Access Compliance Report

Public Rights-of-Way

(Curb Ramps)

Intersection ID: 8311	Main Street: BUTLER_RD	Cross Street: INTERURBAN_AV	Location:	W
ADA ID: F45E93D3F2B1	Ramp Type: Perp	Initial Pass/Fail: Fail	Overall Compliance: No	Severity Score: 10
Codes/Mitigation Info/Possible Solution		Field Measurements/Component Compliance

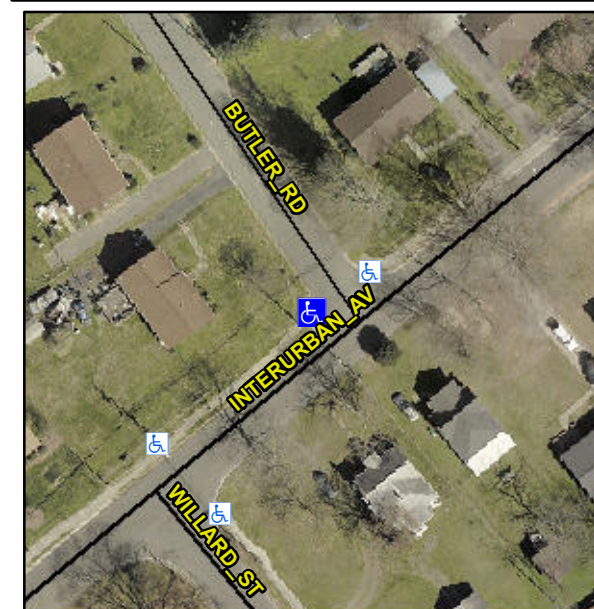
Not Found, R304.5.1, R304.5.3

Compliance	Description	Data	Compliance	Description	Data
N/A	Ramp Length (in)	24.0	Yes	Ramp Slope (%)	6.1
No	Ramp Width (in)	37.5	No	Ramp XSlope (%)	2.8
N/A	Flare Type LT	N/A	N/A	Flare Type RT	N/A
N/A	Flare Slope LT (%)	N/A	N/A	Flare Slope RT (%)	N/A
N/A	Flare Traversable LT?	N/A	N/A	Flare Traversable RT?	N/A
N/A	Landing Length (in)	N/A	N/A	DWS Provided?	N/A
N/A	Landing Width (in)	N/A	N/A	DWS Contrast?	N/A
N/A	Landing Slope (%)	N/A	N/A	DWS Length (in)	N/A
N/A	Landing X Slope (%)	N/A	N/A	DWS Full Width?	N/A
N/A	Landing Curb? (Y/N)	N/A	N/A	DWS Offset (in)	N/A
N/A	Shared Landing?	N/A			
N/A	Gutter Ponding?	N/A	N/A	Gutter Slope (%)	N/A
N/A	Gutter Lip Ht (in)	N/A	N/A	Gutter X Slope (%)	N/A
N/A	Painted X Walk1?	No	N/A	Painted X Walk2?	N/A
	X Walk 1 Direction	To NE		X Walk 2 Direction	N/A
N/A	X Walk 1 Width (in)	N/A	N/A	X Walk 2 Width (in)	N/A
	X Walk 1 Slope (%)	4.7		X Walk 2 Slope (%)	N/A
	X Walk 1 X Slope (%)	4.4		X Walk 2 X Slope (%)	N/A

Remove & Replace Entire Ramp.
